Access Compliance Report

Public Rights-of-Way

Intersection ID: 42727	Main Street: SPEEDWELL_CT	Cross Street: PICKEREL_LN	Location:	N
ADA ID: 98326943E10A	Ramp Type: PerpDiag	Initial Pass/Fail: Fail	Overall Compliance: No	Severity Score: 8.75
Codes/Mitigation Info/Possible Solution		Field Measurements/Component Compliance

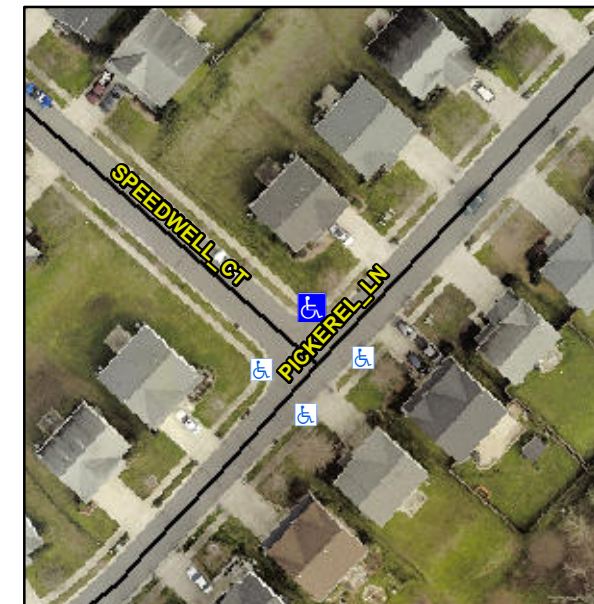
R304.5.1

Compliance	Description	Data	Compliance	Description	Data
N/A	Ramp Length (in)	44.0	Yes	Ramp Slope (%)	6.8
No	Ramp Width (in)	37.0	Yes	Ramp XSlope (%)	1.9
N/A	Flare Type LT	N/A	N/A	Flare Type RT	N/A
N/A	Flare Slope LT (%)	N/A	N/A	Flare Slope RT (%)	N/A
N/A	Flare Traversable LT?	N/A	N/A	Flare Traversable RT?	N/A
N/A	Landing Length (in)	N/A	N/A	DWS Provided?	N/A
N/A	Landing Width (in)	N/A	N/A	DWS Contrast?	N/A
N/A	Landing Slope (%)	N/A	N/A	DWS Length (in)	N/A
N/A	Landing X Slope (%)	N/A	N/A	DWS Full Width?	N/A
N/A	Landing Curb? (Y/N)	N/A	N/A	DWS Offset (in)	N/A
N/A	Shared Landing?	N/A			
N/A	Gutter Ponding?	N/A	N/A	Gutter Slope (%)	N/A
N/A	Gutter Lip Ht (in)	N/A	N/A	Gutter X Slope (%)	N/A
N/A	Painted X Walk1?	No	N/A	Painted X Walk2?	No
	X Walk 1 Direction	To SW		X Walk 2 Direction	To SE
N/A	X Walk 1 Width (in)	N/A	N/A	X Walk 2 Width (in)	N/A
	X Walk 1 Slope (%)	0.7		X Walk 2 Slope (%)	1.4
	X Walk 1 X Slope (%)	1.1		X Walk 2 X Slope (%)	0.8

N/A	Ramp inside XWalk1?	N/A	N/A	Ramp inside XWalk2?	N/A
	Road Slope (%)	0.4	N/A	Clear Space?	N/A
	Road X Slope (%)	0.7	N/A	Clear Space to XWalk (in)	N/A
N/A	Any Obstructions?	N/A	N/A	Storm Grate/Utility Hazard?	N/A
	Obstruction Type			Storm Grate/Utility Type	
		N/A			N/A
			Yes	Surface Condition? (G/P)	Good

Remove & Replace Curb Ramp With Two New Directional Ramps or Equivalent.
